# UNITED STATES PATENT AND TRADEMARK OFFICE

APPLICATION NO.	FILING DATE	FIRST NAMED INVENTOR	ATTORNEY DOCKET NO.	CONFIRMATION NO.
10/811,092	03/26/2004	Erhard Liebig	5034.1002	9737

<b>Office Action Summary</b>	<b>Application No.</b> 10/811,092	<b>Applicant(s)</b> LIEBIG, ERHARD	
	<b>Examiner</b> William H. Rodriguez	<b>Art Unit</b> 3746

Fig. 1

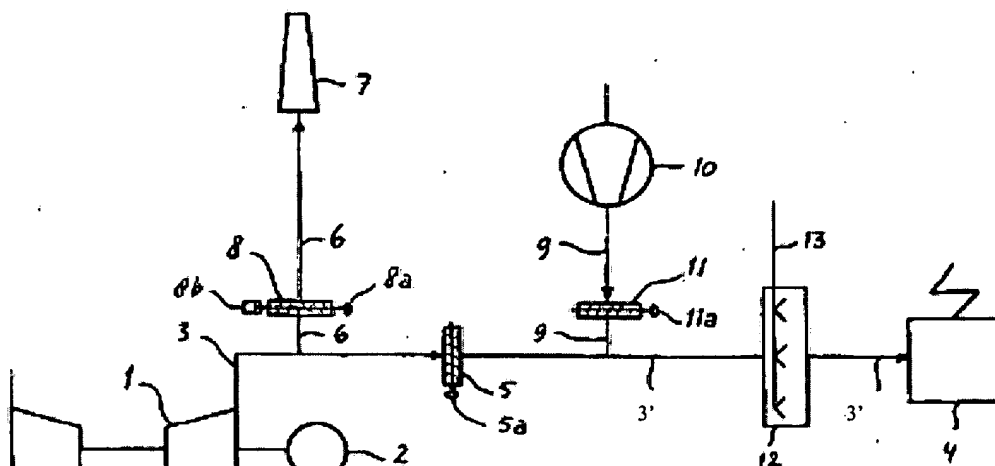
With regards to claims 22 and 23, **Llnnemeyer** teaches an arrangement comprising: a hot-gas generator 1 emitting a mass flow of a hot gas; a technological process 4 disposed downstream of the hot-gas generator; a connector element disposed between the generator and the technological process and configured to feeding a first portion 3' of the mass flow to the technological process; an exhaust 6 including a regulator 8 for discharging a regulated second portion of the mass flow from the connector element and a device 12 configured to influence a temperature of the hot gas disposed between the hot-gas generator 1 and the technological process 4, wherein the hot-gas generator is a combustion engine and the technological process is a steam generator, said influencing includes heating the hot-gas downstream of the hot-gas generator, wherein the heating is performed using an auxiliary combustion, and wherein the auxiliary combustion is performed using said device 12 (burner). See particularly Figure 1 above.

With regards to the method claims 1, 9-15 and 17-21, since **Linnemeyer** has the same structure as claimed, it is inherent that **Linnemeyer's** device would be able to perform the recited method steps. See particularly Figure 1 above.
